**Re: Modification Request – Concept Plan Approval for Redevelopment of the Former Allied Mills Site, 2-32 Smith Street, Summer Hill (MP10\_0155 MOD1)**

## Attachment 1: Architectural Drawing Package

# SUMMER HILL FLOUR MILL\_ SECTIONS

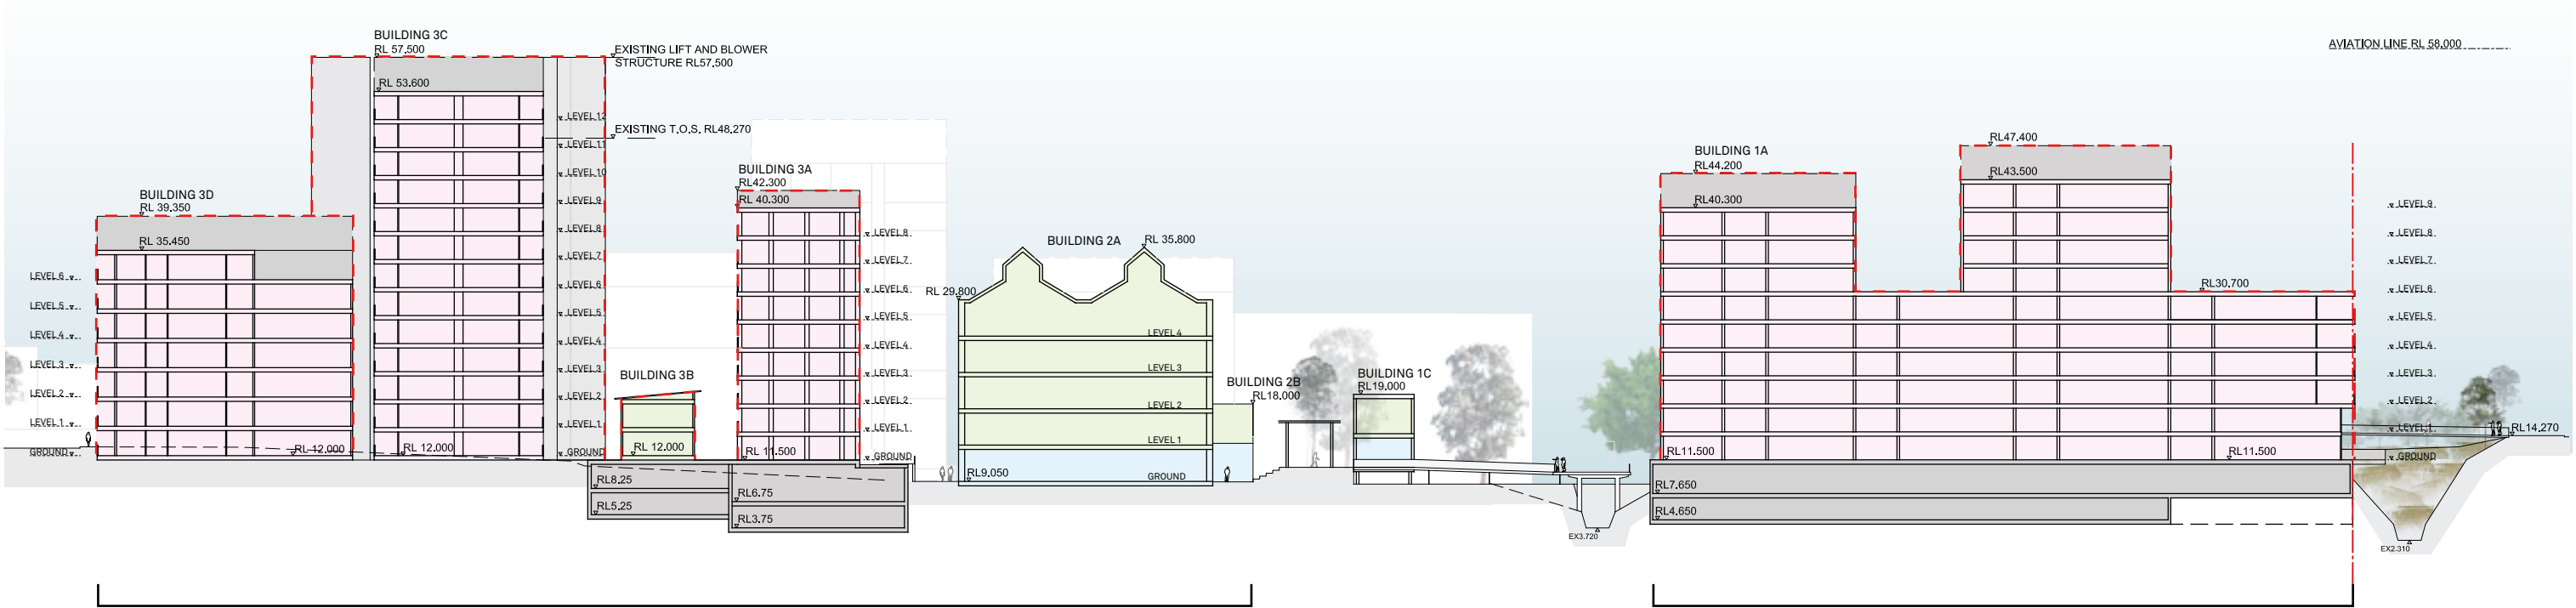
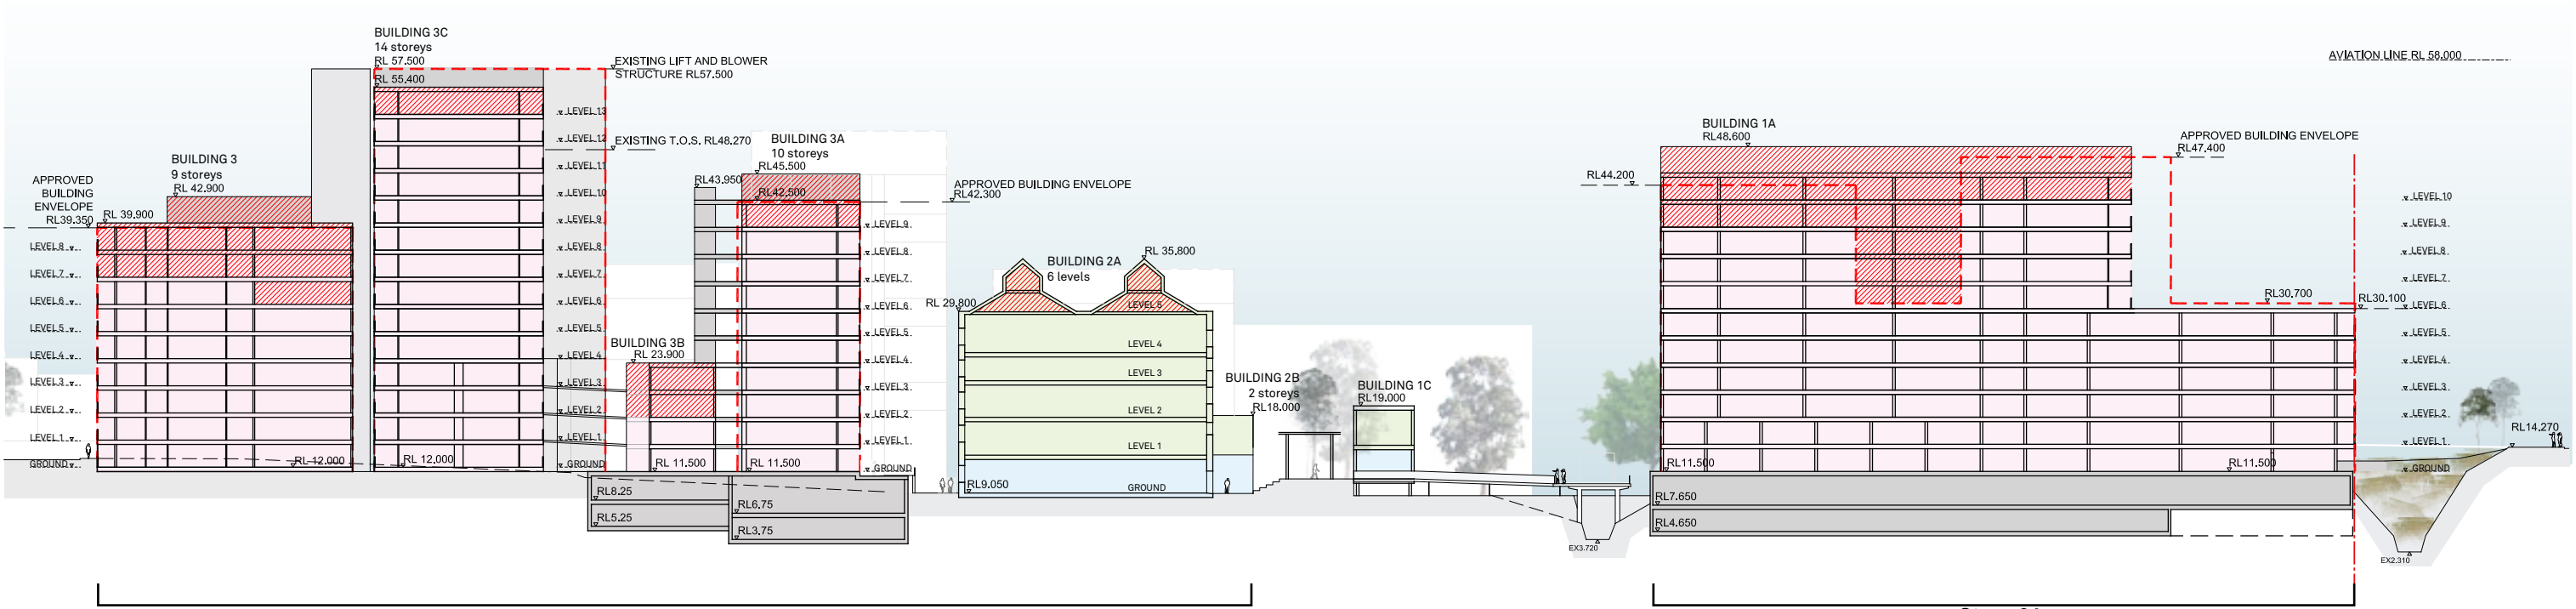
The modification seeks to infill the gap between the two (2) taller elements with a minor increase in the approved envelope height from RL 47.4m to RL 48.6m. The setback of the upper levels from the northern edge of the podium is to be increased from 21.0m to 25.5m.

As indicated in the description of proposed modifications, the footprint of the proposed levels above the six storey podium has been reduced in a north-south extent. This has led to an increase in the setback of the upper levels of Building 1A from the northern extent of the podium from 21.0m to 25.5m.
